APPLICATION NO.	FILING DATE	FIRST NAMED INVENTOR	ATTORNEY DOCKET NO.	CONFIRMATION NO.
09/630,883	08/02/2000	Khosrow Golshan	82259/156	7954

## Office Action Summary

## DETAILED ACTION

FIG. 8

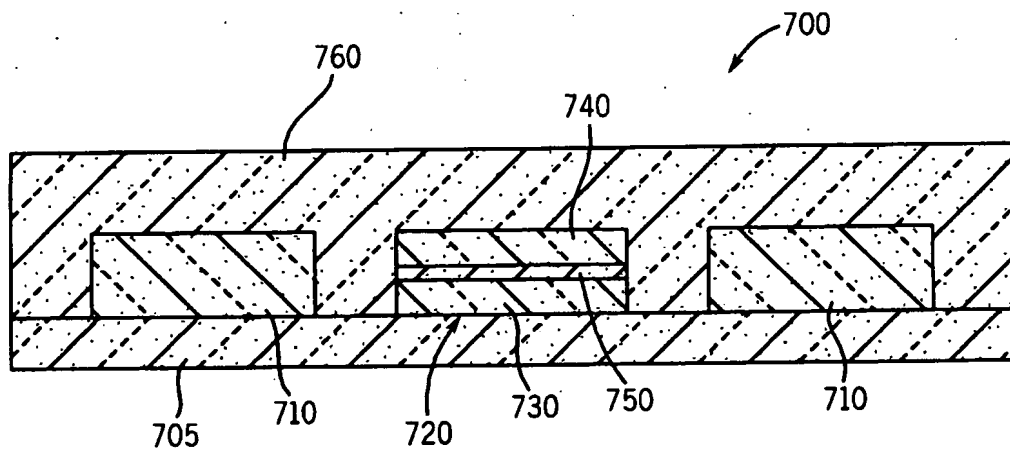
6. The drawings were received on June 20, 2006. **These drawings are NOT Accepted.**
7. The **drawings (filed on June 20, 2006) are objected to as failing** to comply with 37 CFR 1.84(p)(4) because reference characters "720" and "705" have both been used to designate the same element in Figure 8. No explicitly distinction is presented in the Figure. Corrected drawing sheets in compliance with 37 CFR 1.121(d) are required in reply to the Office action to avoid abandonment of the application. Any amended replacement drawing sheet should include all of the figures appearing on the immediate prior version of the sheet, even if only one figure is being amended. Each drawing sheet submitted after the filing date of an application must be labeled in the top margin as either "Replacement

*The applicant is respectfully noted that even though the characters may be explained in the specification to refer to different elements, the drawings are still required to make the distinction between the two. Figure 8 still shows that the same element being designated by both characters “705” and “720”.*

(1). The newly amended phrase “the periphery being a single, outer periphery” recited in the amended claims 47, 55, 65 and 69 is confusing and indefinite for it is not clear what does this “single” mean? Judging from Figure 8, each of the interference regions has outer periphery made up of two parts, (element 760 and element 705). How do these two elements being considered as single periphery?
